Council File No: 22-0163

**Re: 464-466 Crane Boulevard Project - Failure to Provide Notice
May 2, 2023 PLUM Meeting Item # 10, CF No. 22-0163**

Comment for the PLUM hearing for ENV-2020-428-CE

Original Plans

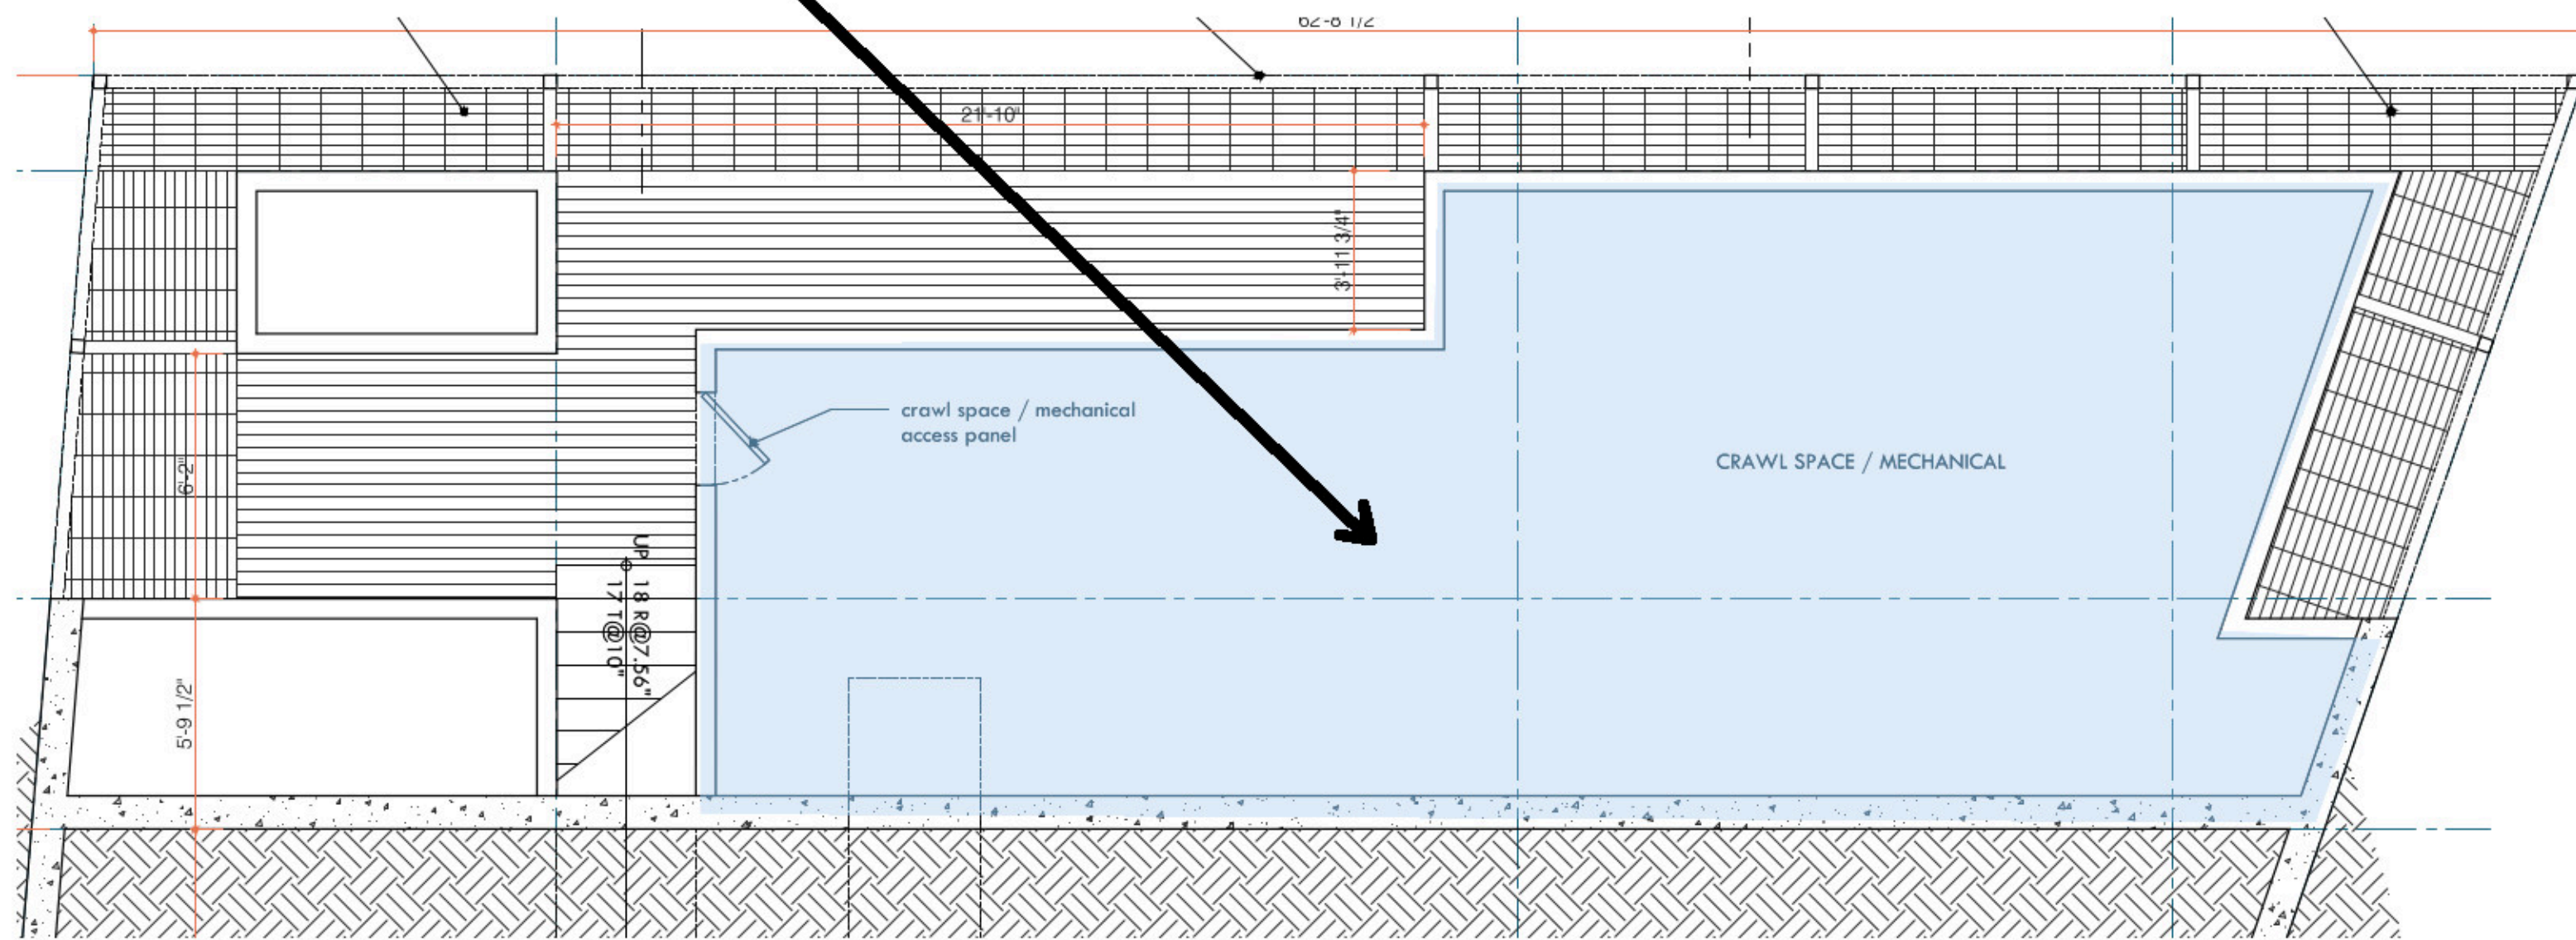
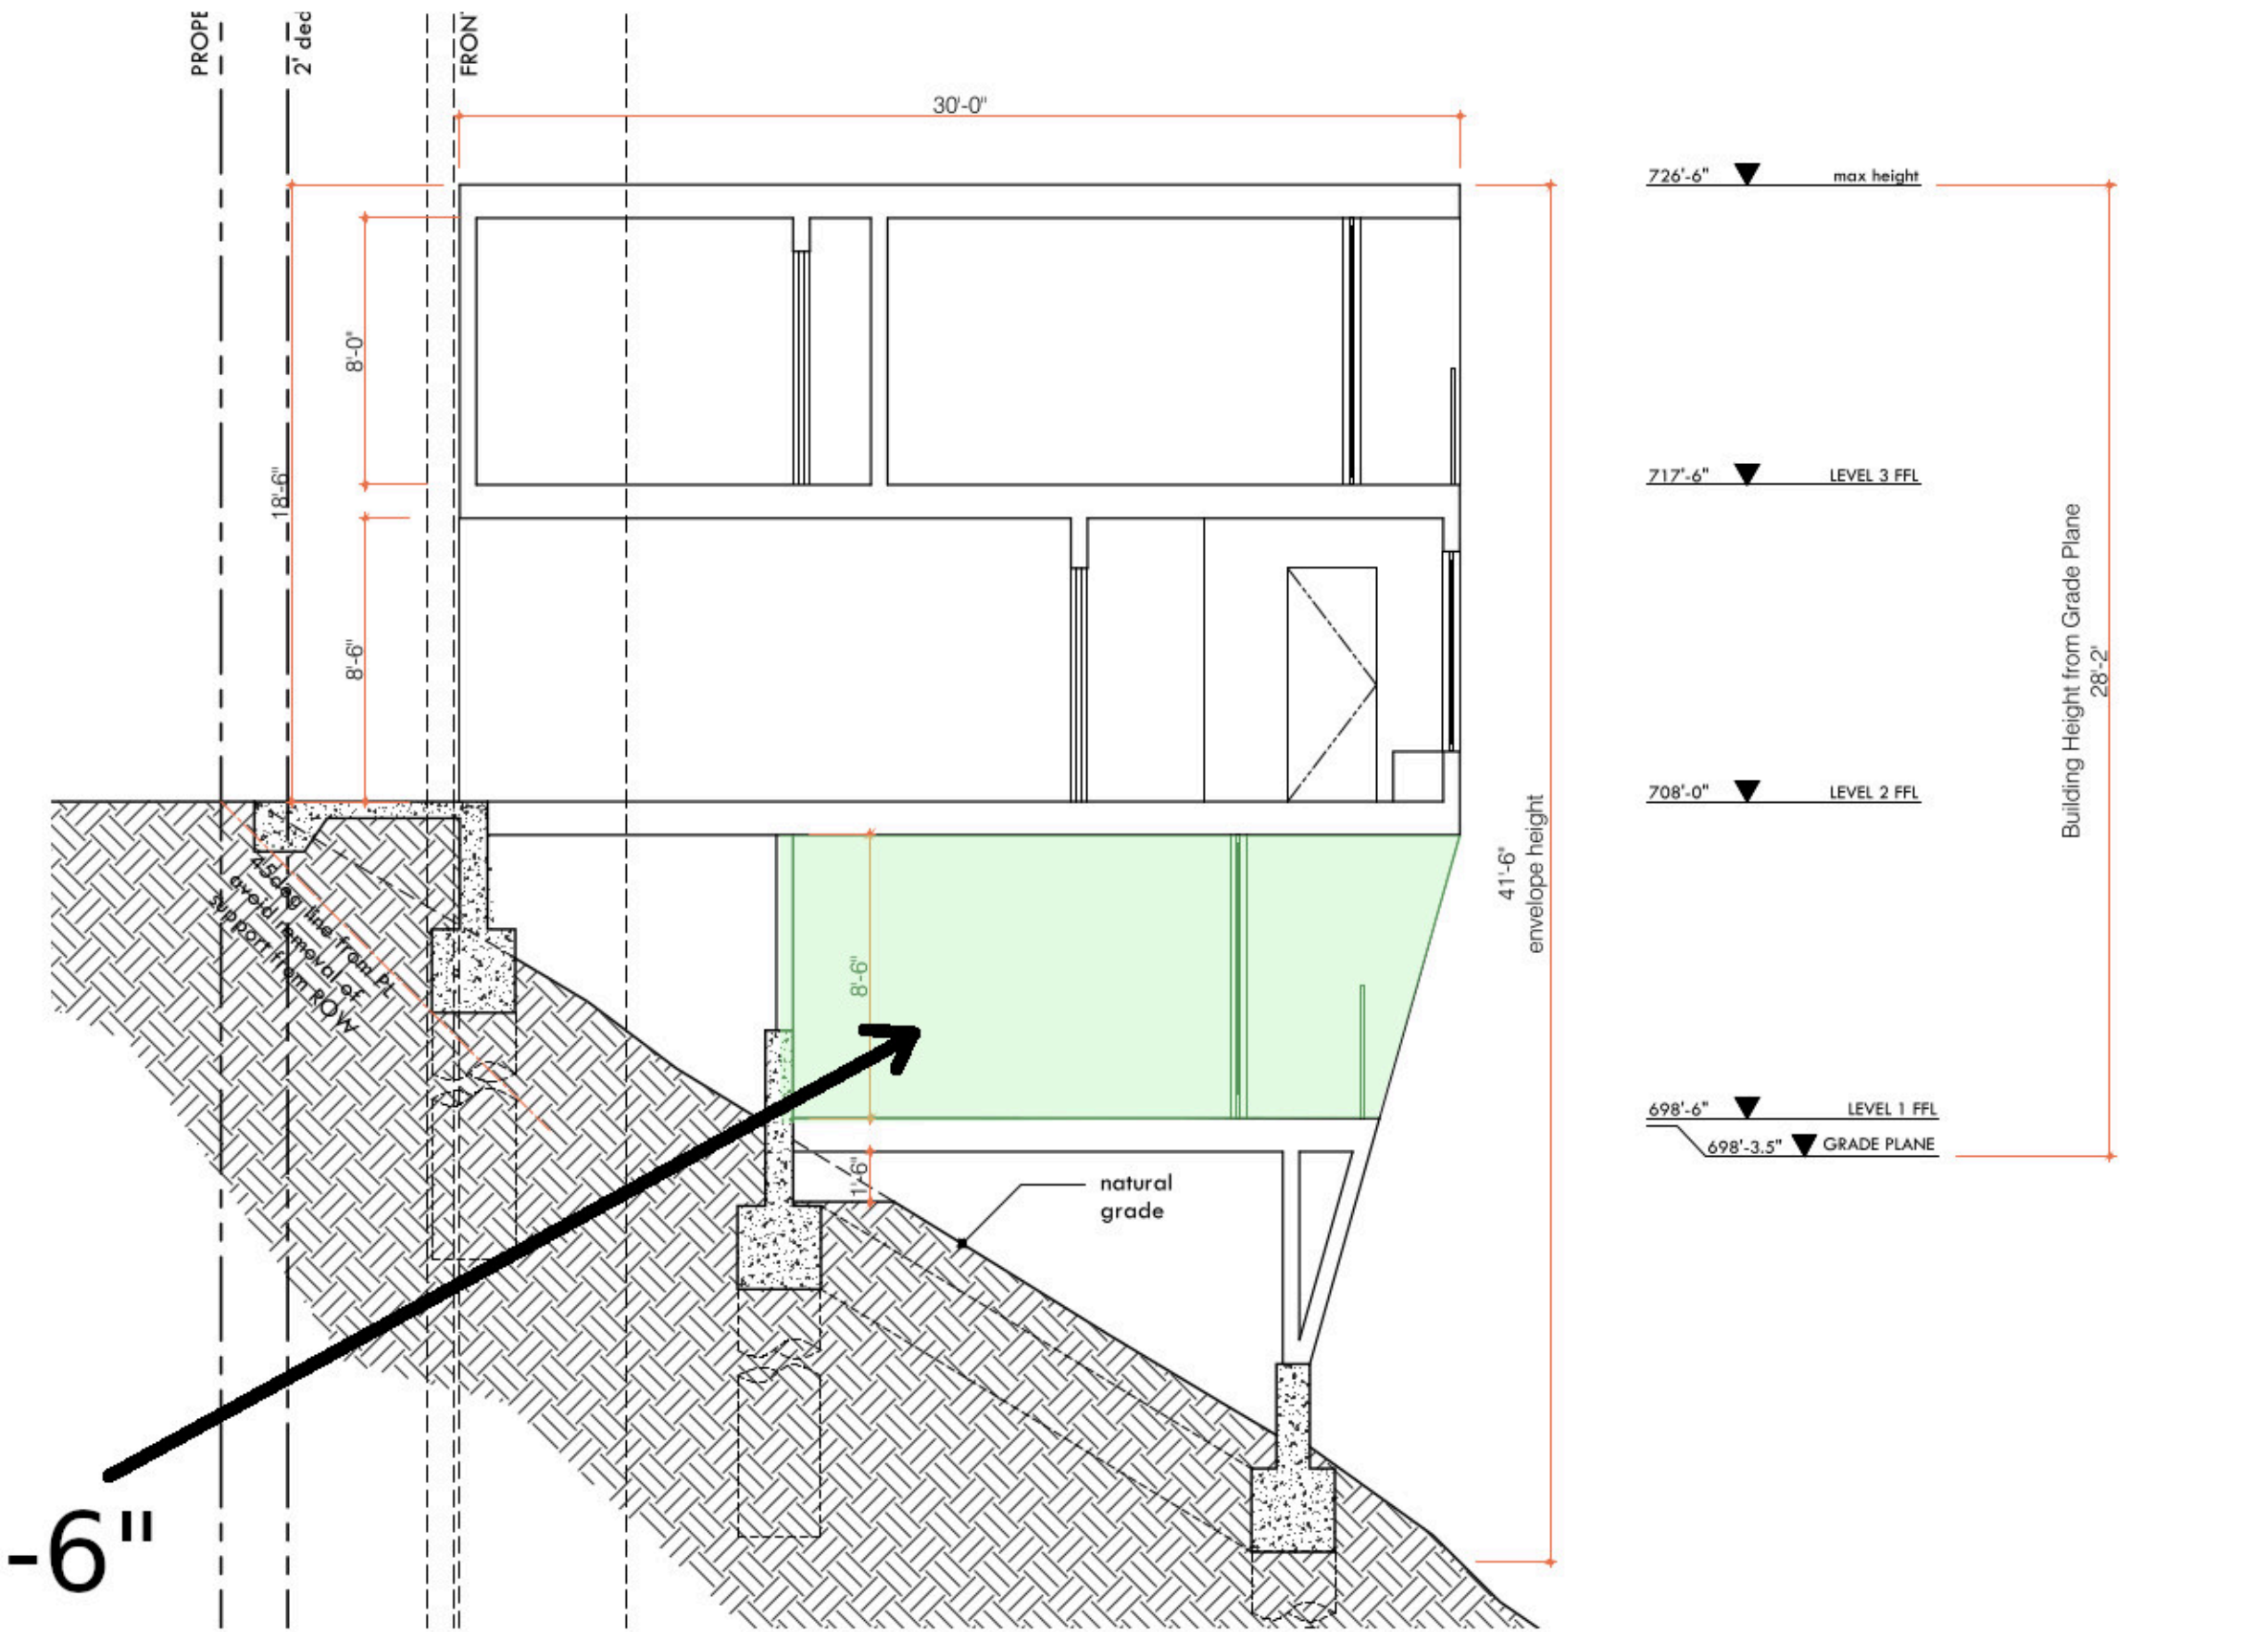
Plans have been intentionally changed to hide the fact that the lowest level is a Story

See the attached selections taken from the project plans. The two at the top are from the original plan and the two at the bottom from the updated plans. You will note that art studio has been relabeled as a mechanical room **BUT** in actuality it will function as whatever the eventual owners will wish it to be. One might think that only a dolt could or would think otherwise, I couldn't say.

Note, the 8'-6" dimension and floor detail that has been deleted. But also, note the floor detail on the floor plan remains – because of course there will be a floor, an enclosed room (which from other details on the plans will have a window, a normal door to “crawl” through (i.e. walk through like a normal person), and have a lovely covered desk surrounding the art studio (oops, a mean mechanical room) with its lattice walls (with dappled sun light filtering through. Sounds nice for a partially submerged, crawlspace, basement.

Per LAMC the lowest level is a Story not a basement, both Planning and the Applicant know this!!

Magically becomes mechanical

8'-6"
Height

Crawl space??
Partially Submerged???
